Access Compliance Report

Public Rights-of-Way

(Curb Ramps)

Intersection ID: 52988	Main Street: LANDING_PLACE_LN	Cross Street: GREYTHORNE_DR	Location: NE
ADA ID: 990C4CA09C52	Ramp Type: BlendTrans1	Initial Pass/Fail: Fail	Overall Compliance: No
		Severity Score: 12.5

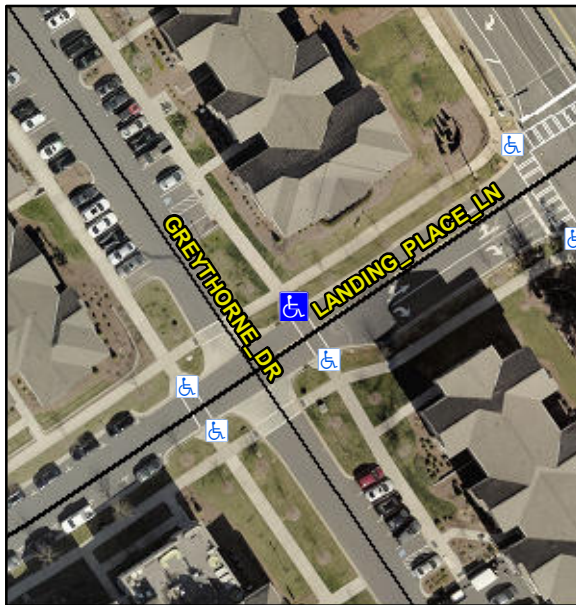
Not Found, R304.5.3

Compliance	Description	Data	Compliance	Description	Data
N/A	Ramp Length (in)	102.0	Yes	BlendTrans Slope (%)	4.3
Yes	Ramp Width (in)	84.0	No	BlendTrans XSlope (%)	5.3
N/A	Flare Type LT	N/A	N/A	Flare Type RT	N/A
N/A	Flare Slope LT (%)	N/A	N/A	Flare Slope RT (%)	N/A
N/A	Flare Traversable LT?	N/A	N/A	Flare Traversable RT?	N/A
N/A	Landing Length (in)	N/A	N/A	DWS Provided?	N/A
N/A	Landing Width (in)	N/A	N/A	DWS Contrast?	N/A
N/A	Landing Slope (%)	N/A	N/A	DWS Length (in)	N/A
N/A	Landing X Slope (%)	N/A	N/A	DWS Full Width?	N/A
N/A	Landing Curb? (Y/N)	N/A	N/A	DWS Offset (in)	N/A
N/A	Shared Landing?	N/A			
N/A	Gutter Ponding?	N/A	N/A	Gutter Slope (%)	N/A
N/A	Gutter Lip Ht (in)	N/A	N/A	Gutter X Slope (%)	N/A
N/A	Painted X Walk1?	Yes	N/A	Painted X Walk2?	N/A
	X Walk 1 Direction	To SE		X Walk 2 Direction	N/A
	X Walk 1 Width (in)	82.0		X Walk 2 Width (in)	N/A
	X Walk 1 Slope (%)	1.3		X Walk 2 Slope (%)	N/A
	X Walk 1 X Slope (%)	4.0		X Walk 2 X Slope (%)	N/A

N/A	Ramp inside XWalk1?	Yes	N/A	Ramp inside XWalk2?	N/A
	Road Slope (%)	4.0		Clear Space?	N/A
	Road X Slope (%)	1.3	N/A	Clear Space to XWalk (in)	N/A
N/A	Any Obstructions?	N/A	N/A	Storm Grate/Utility Hazard?	N/A
	Obstruction Type			Storm Grate/Utility Type	
		N/A			N/A
			Yes	Surface Condition? (G/P)	Good
			No	Curb Slope (%)	13.8

Remove & Replace Curb Ramp With Two New Directional Ramps or Equivalent.
